PIC18F45J10 Family Data Sheet Errata

Clarifications/Corrections to the Data Sheet:

In the PIC18F45J10 Family Device Data Sheet (DS39682**C**), the following clarifications and corrections should be noted. Any silicon issues related to this device will reported in a separate silicon errata. Please check the Microchip web site for any existing issues.

FIGURE 23-2: PIC18LF45J10 FAMILY VOLTAGE-FREQUENCY GRAPH (INDUSTRIAL)

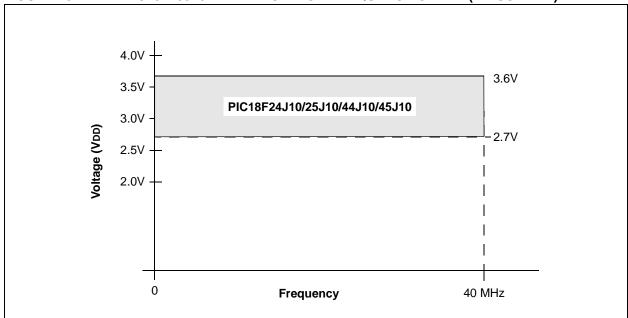
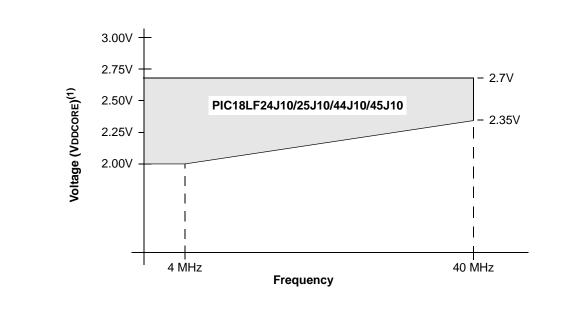
Figures 23-1 and 23-2 of the device data sheet, documenting frequency performance of the devices across the VDD range, have been updated. The new versions of the graphs are presented below.

Note 1: For these devices, the regulator BOR circuit will automatically trigger a device Reset before VDD reaches a level at which full-speed operation is not possible.

For frequencies between 4 MHz and 40 MHz, FMAX = (51.42 MHz/V) * (VDDCORE - 2V) + 4 MHz

Note 1: For devices without the voltage regulator, VDD and VDDCORE must be maintained so that VDDCORE \leq VDD \leq 3.6V.

8. Module: Figure 15-9: I²C[™] Slave Mode Timing (Transmission, 7-Bit Address)

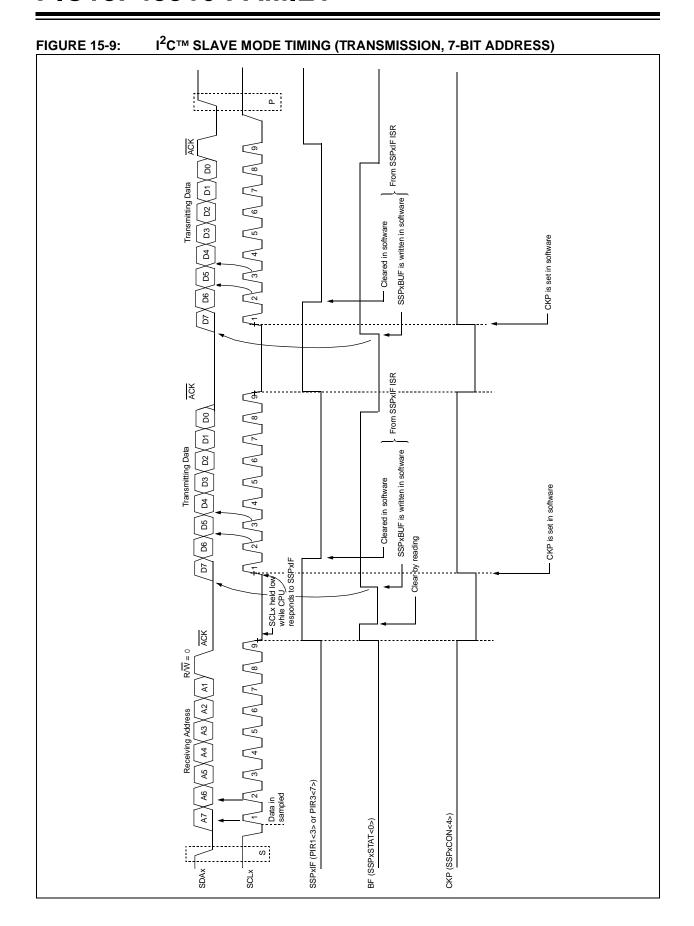
On page 162, the figure is replaced with a new timing diagram provided in Figure 15-9.

9. Module: Figure 15-22: I²C™ Master Mode Waveform (Reception, 7-Bit Address)

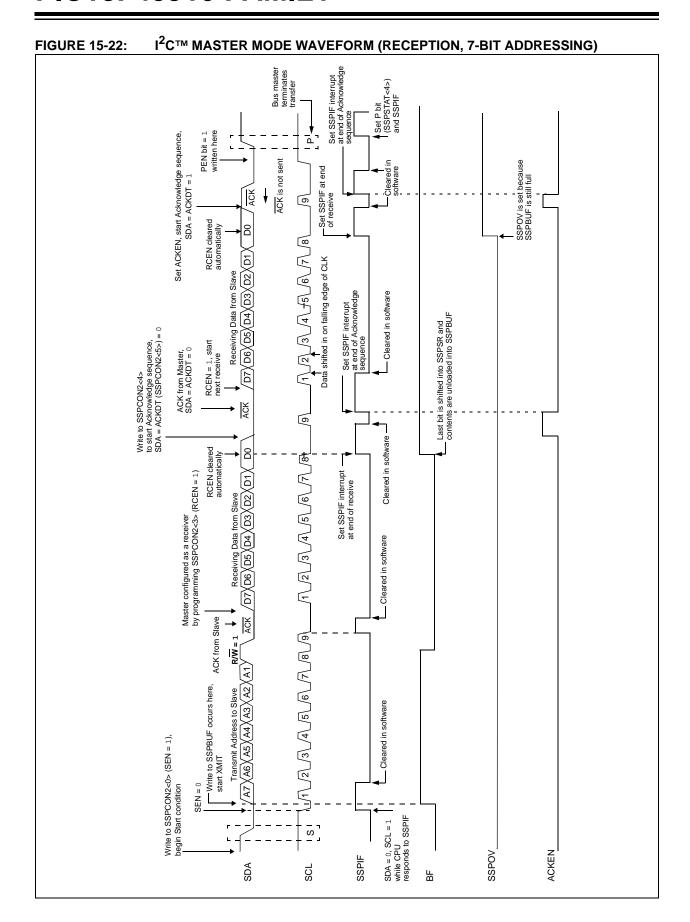
On page 178, the condition (R/\overline{W}) when the Acknowledge signal (ACK) is received from the slave, after transmitting the address to the slave, is changed to '1'. The changed value is indicated in bold text in Figure 15-22.

FIGURE 9-1: GENERIC I/O PORT OPERATION

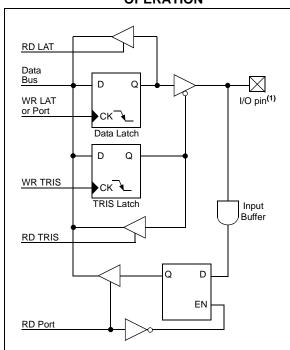
The note in Figure 9-1 on page 93 is removed.
